14TH & MADISON
1401 EAST MADISON

DESIGN REVIEW RECOMMENDATION #2
DPD #3020065 / 27 JULY 2016

SWISSPEARL LINEARIS SIDING MOCKUP

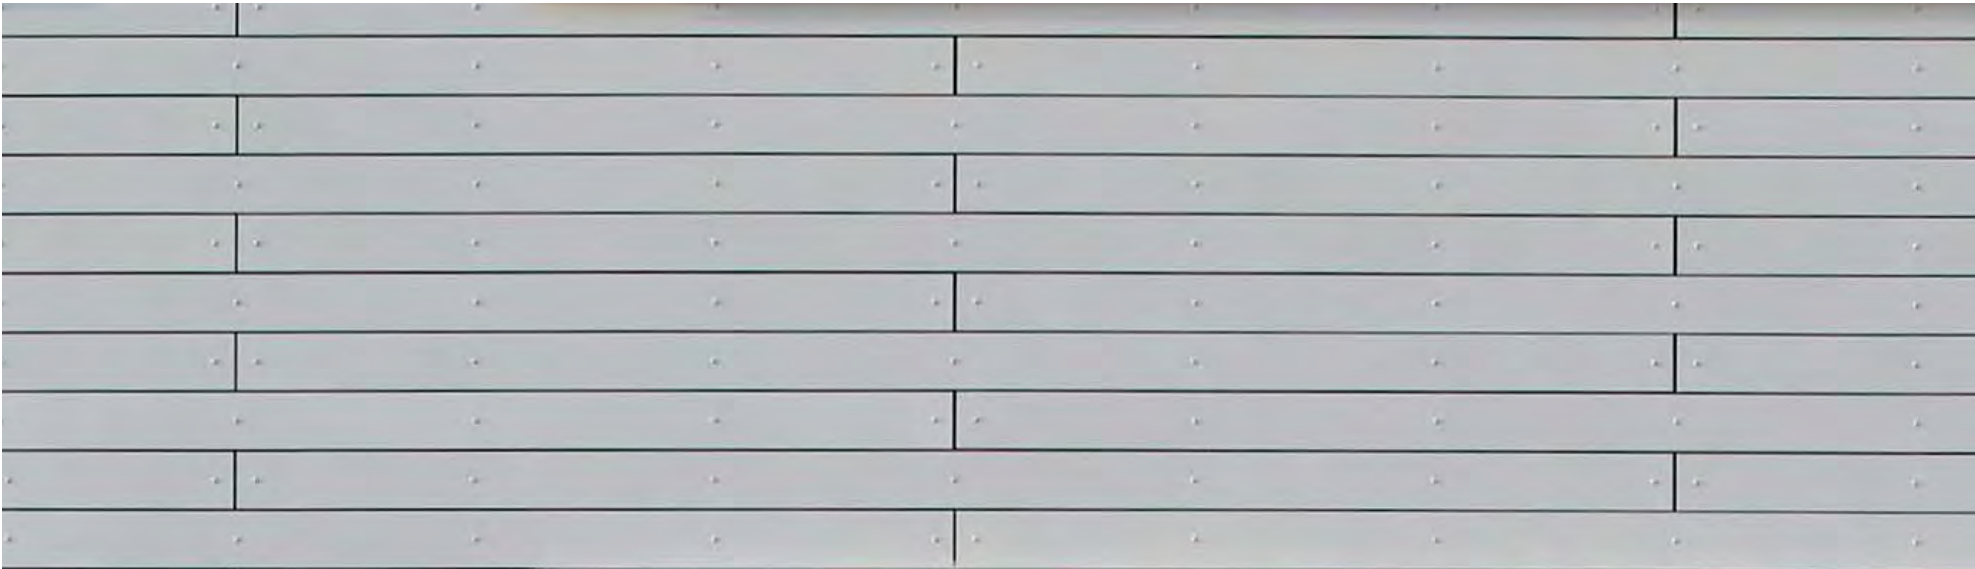
- a. The Board recommended further study of panel material detailing and noted that exposed fasteners will make the material read like a panel.

Per Board recommendation, we have created a mockup to show detailing of Swiss Pearl Linearis panel material on a rainscreen facade. SwissPearl is an integral color cement-based panel. This mockup shows the actual panel height 147 mm (5 13/16"), typical fasteners that will be used as well as typical panel joint spacing (min. 3/16" wide for vertical joints and 3/12" wide for horizontal joints. Typical joint width is 5/16". NOTE: Actual fastener spacing is 16" o.c. Fasteners will be aligned to support the urban edge concept (uniform, straightforward expression) (**DC4-A**).

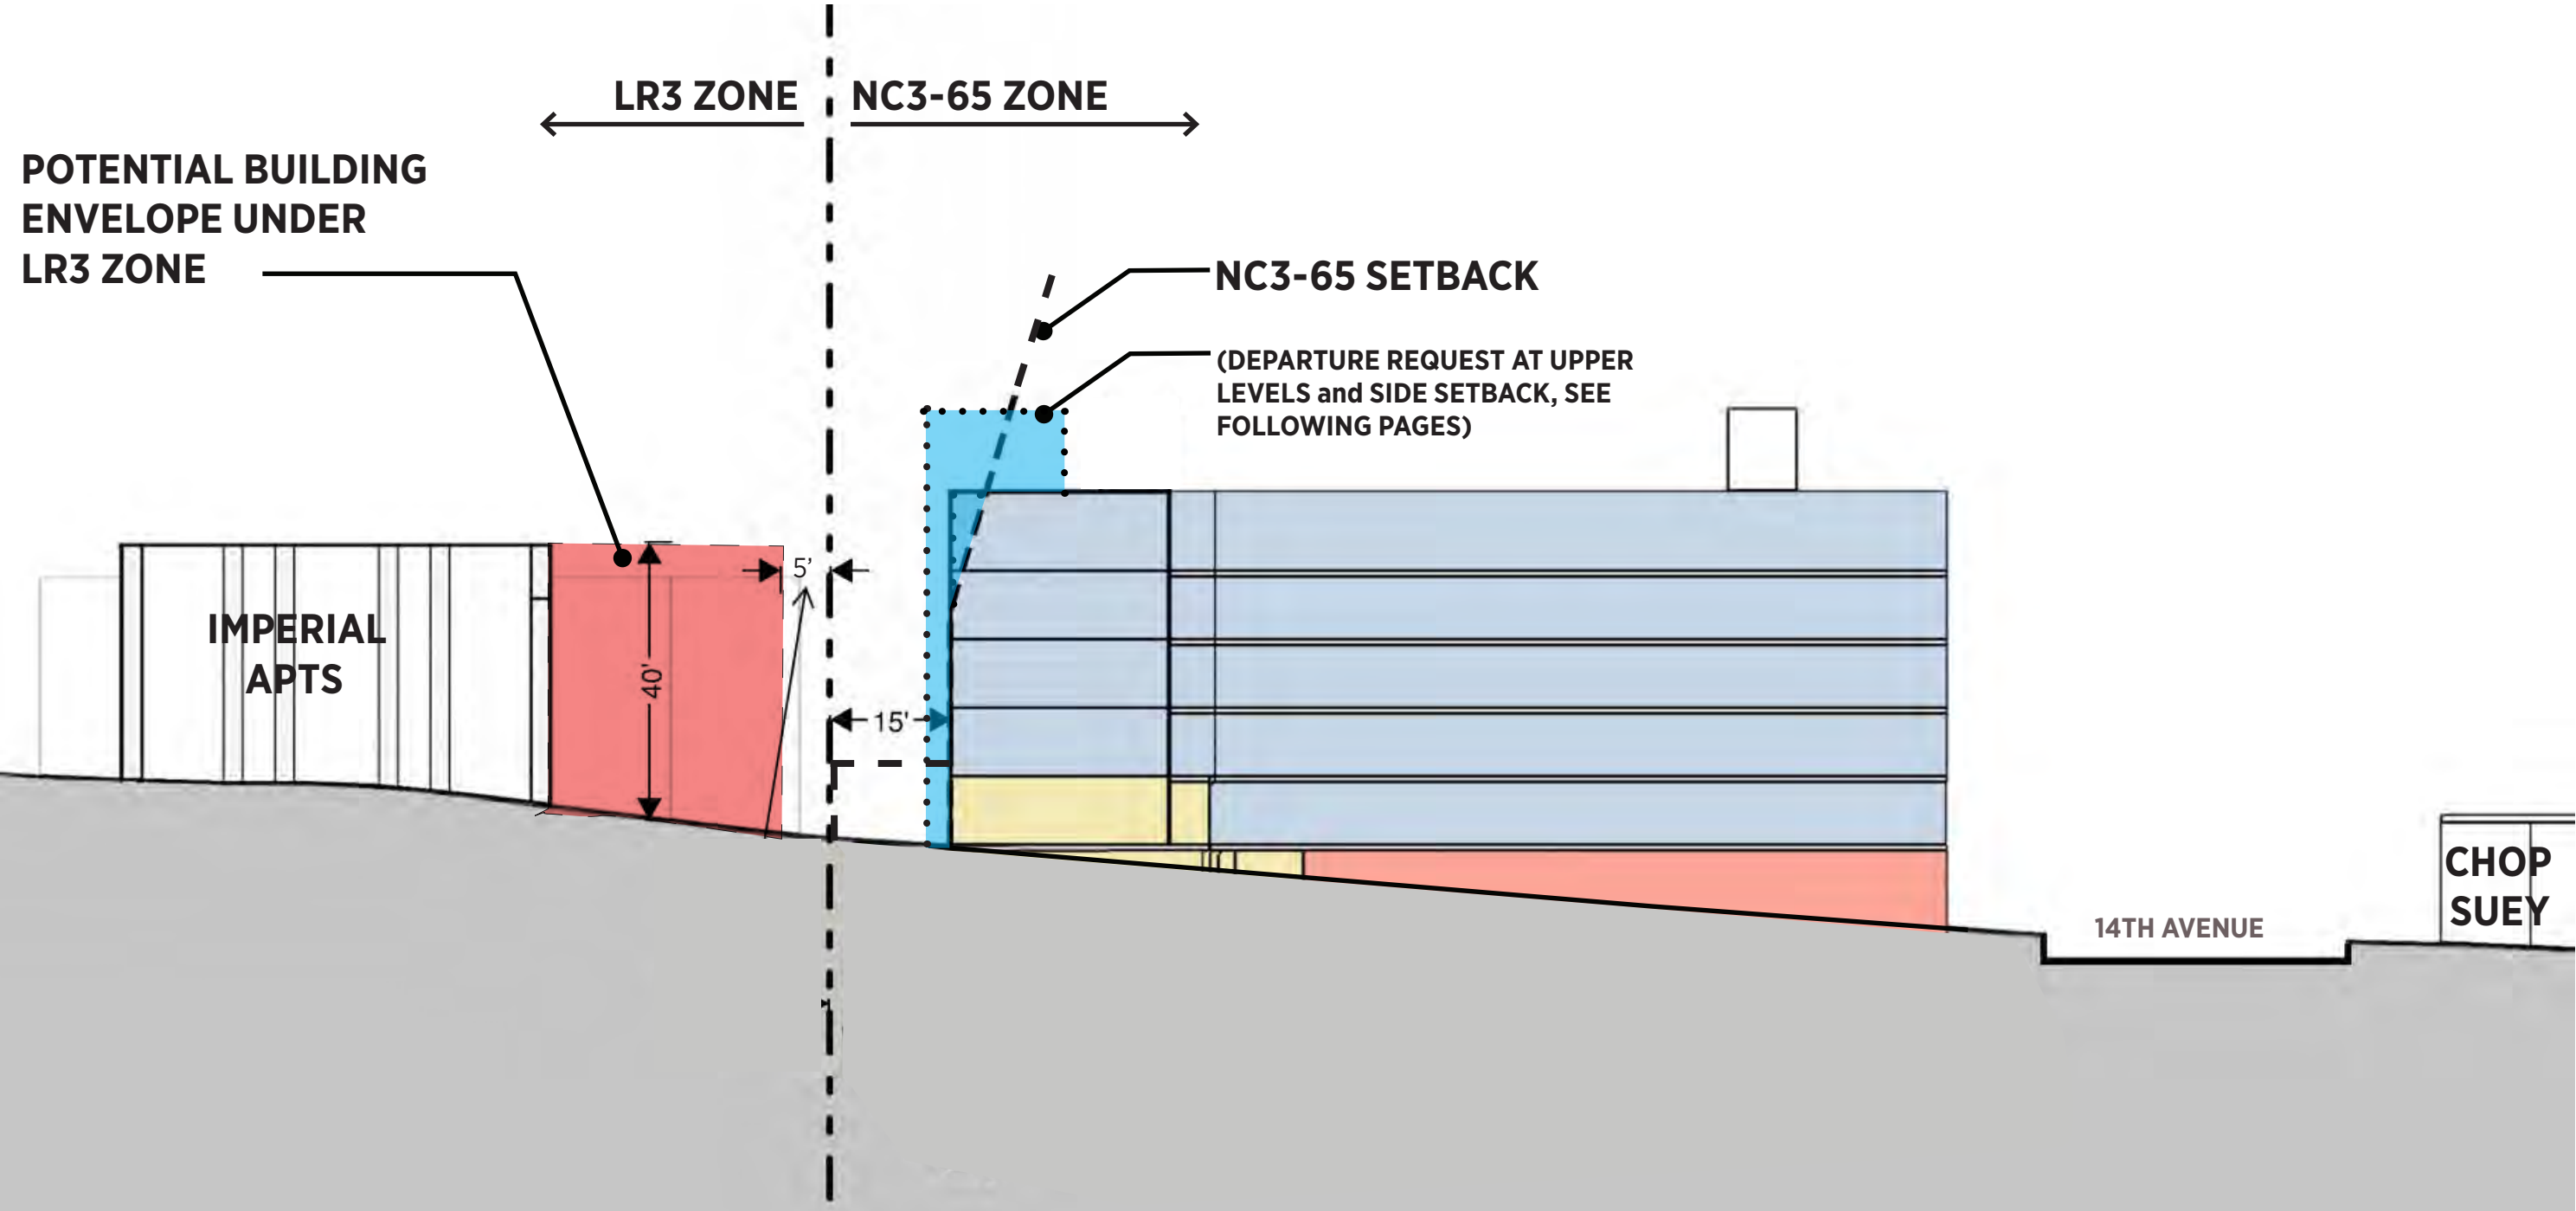
b. The Board recognized that there are a many different materials, tones and textures proposed and recommended simplifying the variation, similar to the precedent image shown on page 46.

Per board direction, simplified material palette especially at the ground floor. Removed two different types of glazing to unify the storefront expression at the base. We carried the boardformed concrete expression.
